**Commonwealth of Pennsylvania
Department of Environmental Protection
Southwest Region**

**Review of the Environmental Integrity
Project and Earthjustice Report:**

Out of Control: Mounting Damages From Coal Ash Waste Sites

**October 13, 2010
Revised October 27, 2011**

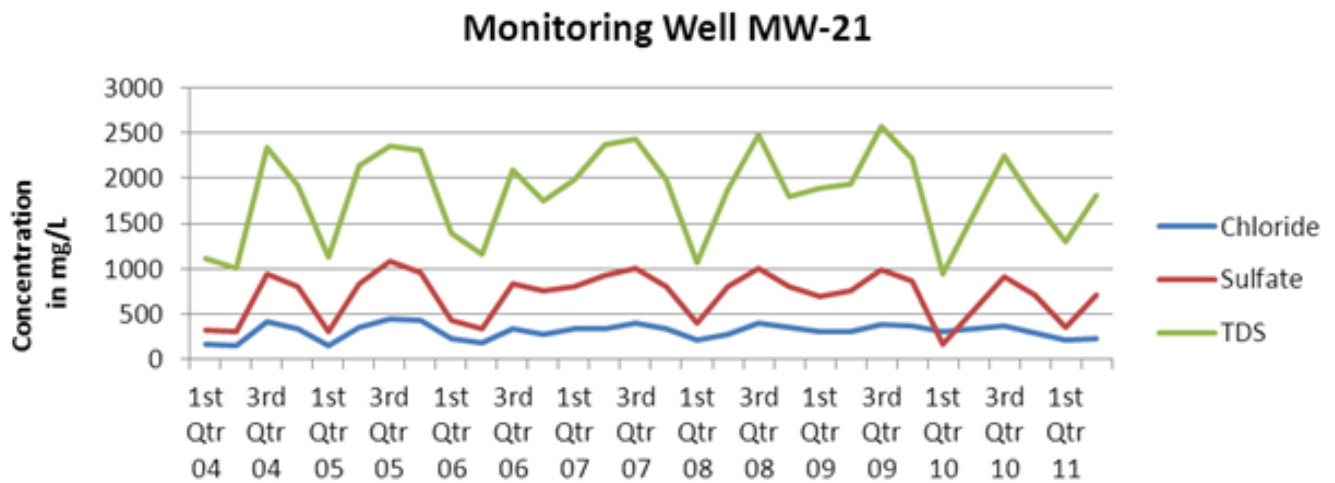
- From 1997 to 2006 boron in MW-12 regularly exceeded 1 mg/L. Throughout this period, 1 mg/L was equal to EPA's health advisories for boron. Although EPA relaxed those advisories to 3 mg/L in 2009, 1 mg/L is at or above health based standards for boron in drinking water used by other regulatory agencies such as the European Union (1.0 mg/L), World Health Organization (0.5 mg/L) and Minnesota Department of Health (1.0 mg/L). During the same time period concentrations of chloride, sulfate and TDS also regularly exceeded the secondary MCL in this well.

This statement is misleading. Monitoring well MW-12 is an upgradient well and has been affected by acid mine drainage. As stated by the EIP, the measured levels of upgradient boron are less than the current EPA's advisory level of 3 mg/L. It should be noted that EPA health advisories are non-enforceable, guidance-based concentrations based on non-cancer health effects for different exposures in drinking water sources. The drinking water standards established by the World Health Organization and the Minnesota Department of Health are irrelevant to this discussion as this facility is not required to address those limits. Chloride, sulfate and TDS are secondary drinking water parameters which address aesthetic issues and are not health based.
